UNITED STATES PATENT AND TRADEMARK OFFICE

Office Action Summary	Application No. 10/692,521	Applicant(s) ROSENBERG, ABRAHAM	
	Examiner Yvonne M. Horton	Art Unit 3635

DETAILED ACTION

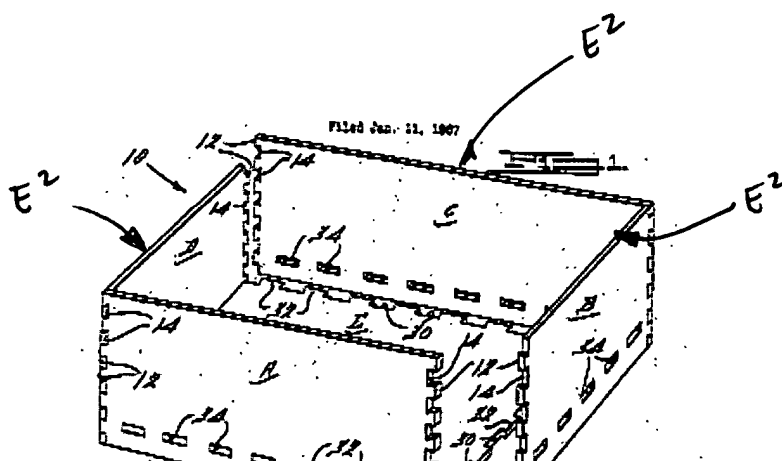
Claims 1-8 are rejected under 35 U.S.C. 102(b) as being anticipated by US Patent #3,442,311 to RHYNE. RHYNE discloses the use of a prefabricated "housing" structure including a first and second plurality of walls (A-E), a first connection means (12,14) disposed to connect the plurality of first walls (A-D) to the plurality of second walls (A-D), a second connection means (34) disposed to connect the first walls (A-D) to other first walls (A-D), and a third connection means (12,14) disposed to connect the plurality of second walls (A-D) to another plurality of second walls (A-D). Each of the first and second walls (A-D) having an edge ($\overset{2}{E}$) defining a perimeter wherein the edge ($\overset{2}{E}$) along a full length thereof is flat and without any of the first, second or third

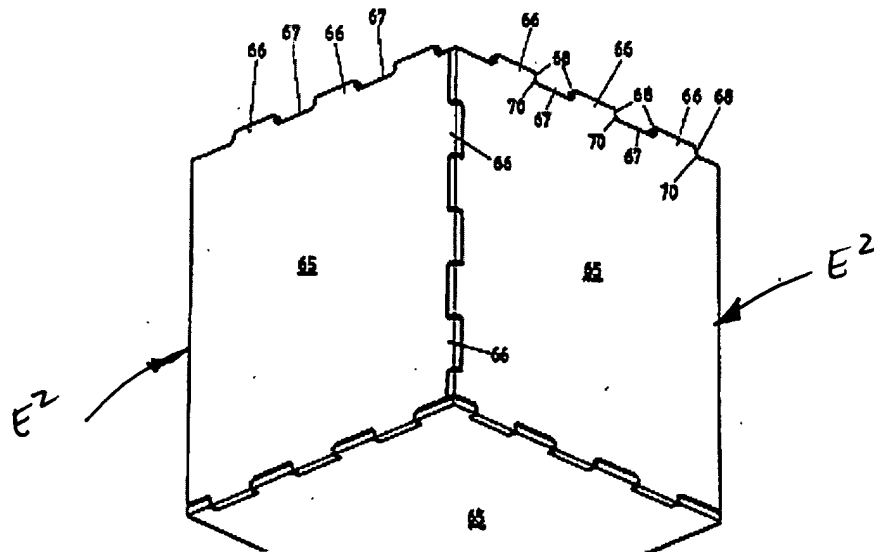
Claim 13 is rejected under 35 U.S.C. 103(a) as being unpatentable over US Patent #3,442,311 to RHYNE. RHYNE discloses the basic claimed "housing" structure as detailed above, except his short edges have the connection means disposed there along. Although the structure of RHYNE have long edges that are straight, it would have been obvious to one having ordinary skill in the art at the time the invention was made to form the short edges as the straight edges, since the mere reciprocation of essential working parts of an invention involves only routine skill in the art.
